**Appendix [A] to Applicant's Responses to ExA Written Questions (ExQ1)**

**Appendix [B] To Applicant's Responses to ExA Written Questions (ExQ1)**

**Appendix [F] to Applicant's Responses to ExA Written Questions (ExQ1)**

**Figure ExQ1\_Landscape supporting Applicant's response to ExQ 1.8.4**

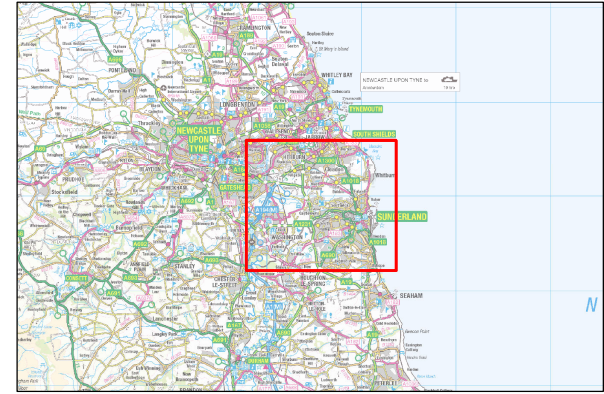
<p><b>Q1.8.4</b></p>	<p>In paragraph 8.5.27 of the ES [APP-020] the site is described as straddling two National Character Areas (NCAs).</p> <p>The Applicant is asked to show the boundaries of the NCAs in relation to the Site.</p>	<p>The NCA boundaries were not included on ES Figure 8.1 due to the local context and scale of the Scheme proposals in relation to the study area. Therefore, NCA boundaries were identified within the ES text and appendices only.</p> <p>Figure ExQ1_Landscape located in <b>Appendix [F]</b> has been prepared specifically for this response, has been prepared to illustrate the boundary of the NCAs.</p>

Drawing Title **SUPPORTING DRAWING FOR EXQ1 QUESTION 1.2.1**

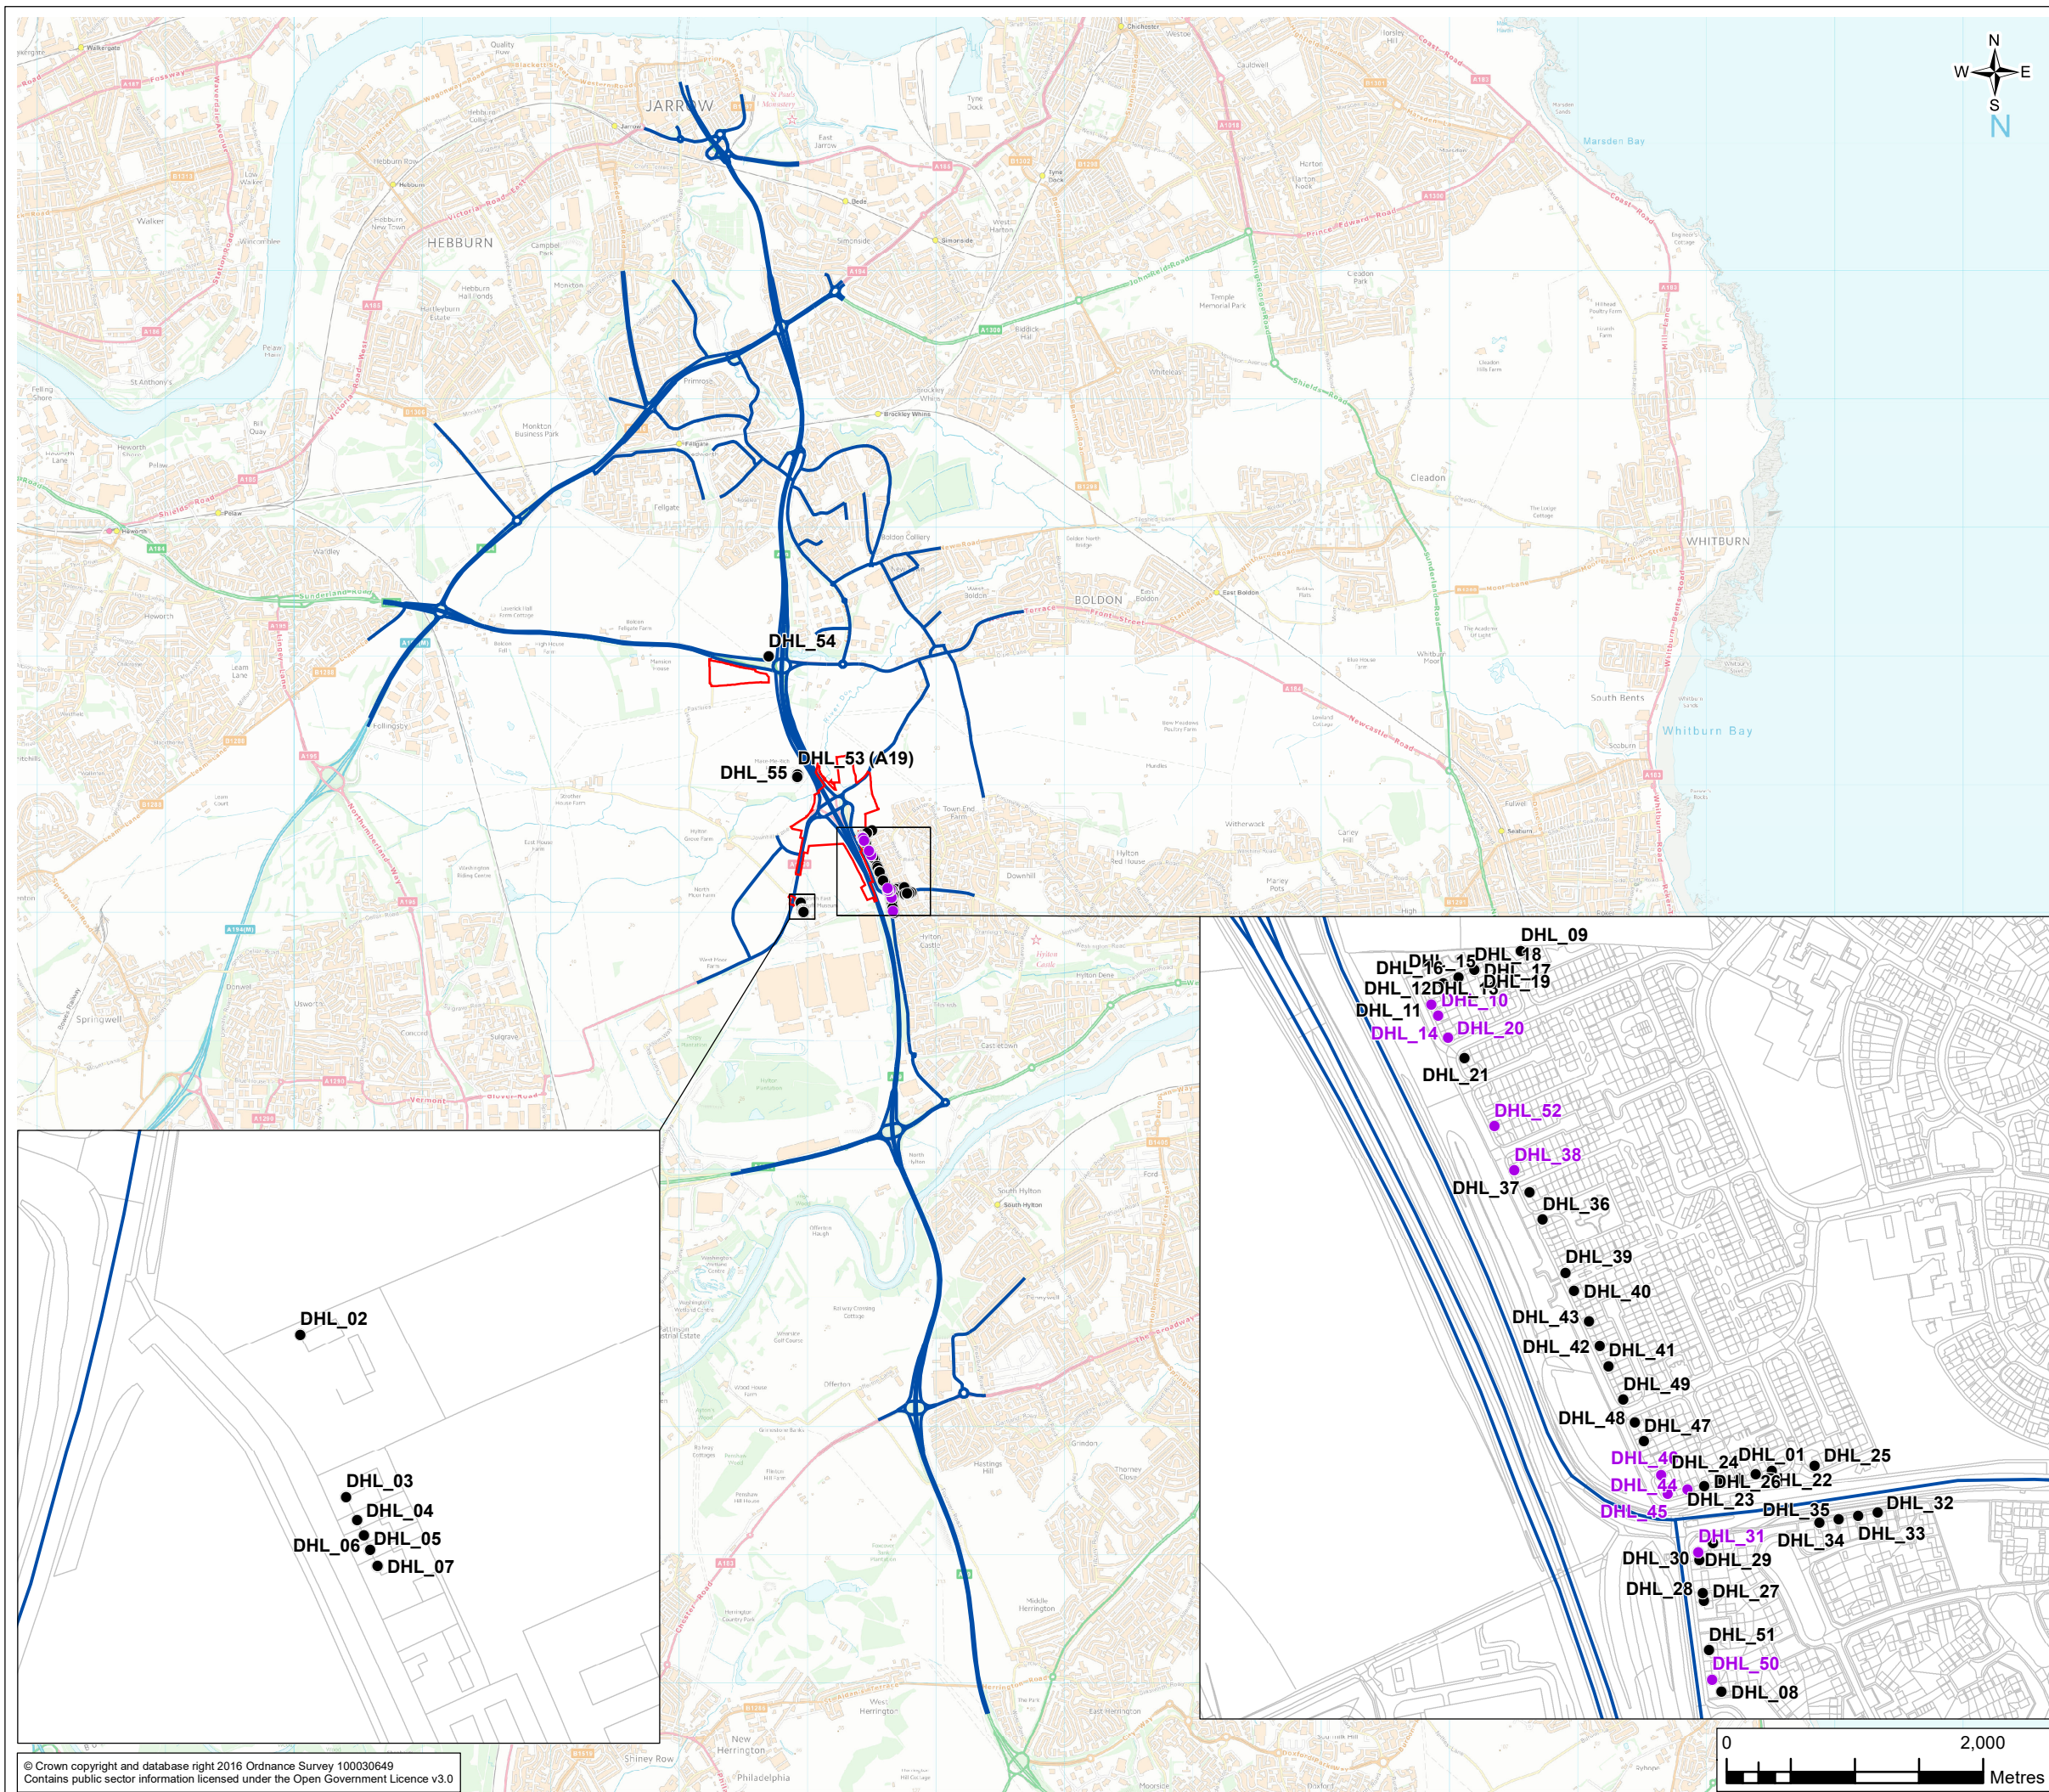
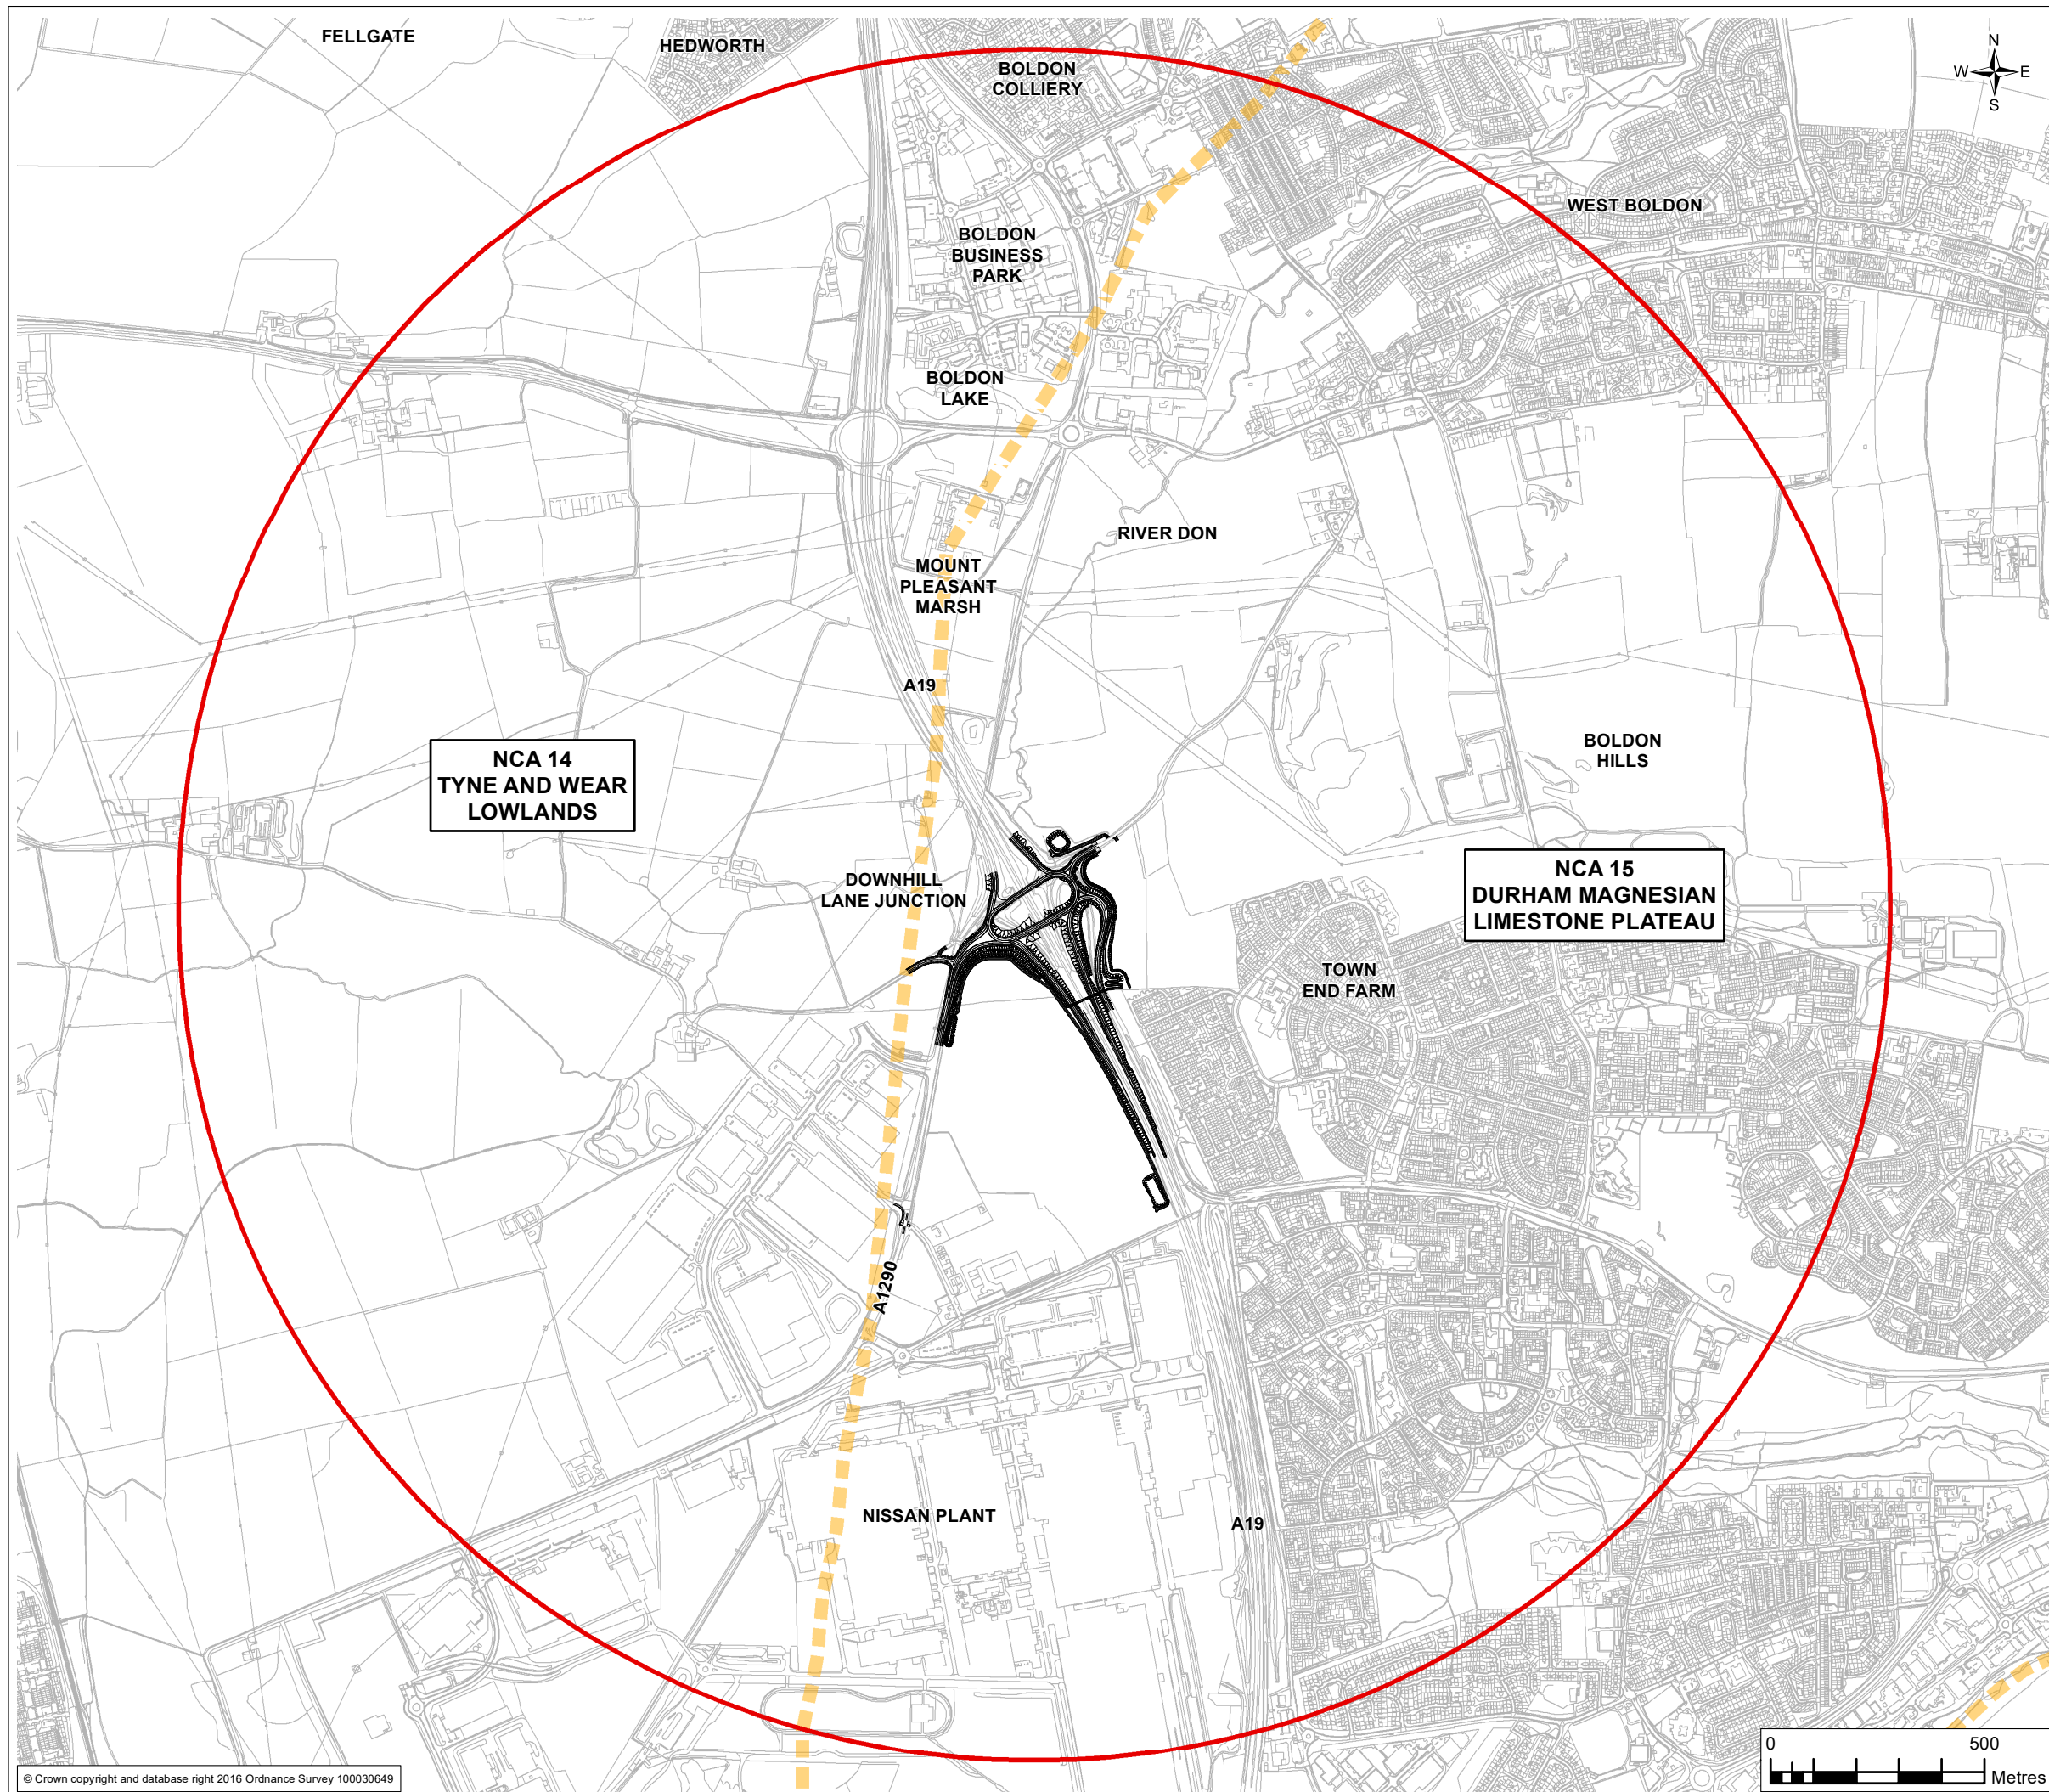
Ref No.	Question:	Response:
2	<b>Air Quality and Emissions</b>	
Q1.2.1	<p>Paragraph 6.3.7 of the ES [APP-020] states that the study area for the assessment of air quality was defined by identifying all sensitive receptors 200m from the affected road network. Paragraph 6.3.9 refers to Figure 6.1 [APP-023] indicating that it illustrates the air quality study area and constraints and that the study area covers the Downhill Lane junction, sections of the A19 and sections of the A1290. Figure 6.1 shows the modelled road network whilst Figure 6.2 and subsequent figures show the position of 10 receptors with the highest concentrations within Table 6.5-a in Appendix 6.5 [APP-33] identifying all 55 receptors.</p> <p>The Applicant is asked:</p> <ul style="list-style-type: none"> <li>to clarify how the 55 receptors were identified and to show them on a plan to enable the study area boundary to be mapped;</li> <li>to clarify how the modelled road network was identified and whether this is different from affected roads;</li> <li>with respect to Figure 6.1 to show the affected road links which the key indicates are shown as red or green in colour but do not appear to be shown other than a short stretch of Washington Road - is this because there would be no affected roads subject to an increase in traffic?; and</li> <li>to explain why the modelled road network includes only Washington Road and Ferryboat Lane within the quadrant to the south east of the application site.</li> </ul>	<p>The Applicant notes that the elements of this questions are interlinked. The Applicant has therefore dealt with the questions together.</p> <p>As outlined in paragraphs 6.2A.19 to 6.2A.22 in Appendix 6.2 of the Environmental Statement (<b>Application Document Reference: TR010024/APP/6.3</b>) [APP-033] the assessed 55 air quality receptors were identified as air quality sensitive receptors (e.g. residential properties, schools nursing homes or statutory designated nature conservation sites) located within 200m of the 'affected' road links (road links where the change in traffic data meets DMRB criteria as detailed below) and screened using professional judgement for being:</p> <ul style="list-style-type: none"> <li>Representative of maximum impacts of the Scheme in region; and</li> <li>At risk of exceeding the annual mean NO<sub>2</sub> AQO.</li> </ul> <p>Ordnance survey address data was used to identify sensitive properties. This is standard and accepted practice for roads air quality assessment, and is discussed in various guidance, including DMRB HA207/07.</p> <p>The 55 identified sensitive receptors (properties) are illustrated on Figure ExQ1_AQ contained in <b>Appendix [F]</b> of this document.</p> <p>The modelled road network is formed by affected road links and based upon the outputs of a traffic model, so was subject to the assumptions applied to, and limitations of, the model (see Section 5.4 of the Environmental Statement (<b>Application Document Reference: TR010024/APP/6.1</b>) [APP-020]. Following identification of all receptors within 200m of the affected road links, any other available road links within 200m of those receptors are identified and added to form the modelled road network used in the air quality assessment. Additional roads were modelled to inform the verification calculations.</p> <p>Affected road links are defined by DMRB HA207/07, as described in ES paragraph 6.3.8 (<b>Application Document Reference:</b></p>

Ref No.	Question:	Response:
		<p><b>TR010024/APP/6.1)</b> [APP-020], and shown on top of the Traffic Modelled Road Network in Figure 6.1 (<b>Application Document Reference: TR010024/APP/6.2)</b> [APP-023]. The affected road links are mainly within the yellow land-take boundary - these include the A19 carriageways, Downhill Lane Junction and the A1290, together with Ferryboat Lane.</p> <p>Only 10 receptors were presented in Chapter 6 of the ES (<b>Application Document Reference: TR010024/APP/6.1)</b> [APP-020] to represent those with the highest concentrations, and the closest in proximity to the affected road links of the Scheme. However, the assessment results for all 55 receptors were included in Appendix 6.5 of the ES for completeness (<b>Application Document Reference: TR010024/APP/6.3)</b> [APP-033]. Of the 55 receptors assessed for the local air quality assessment, none were predicted to exceed the NO<sub>2</sub> or PM<sub>10</sub> AQOs.</p>
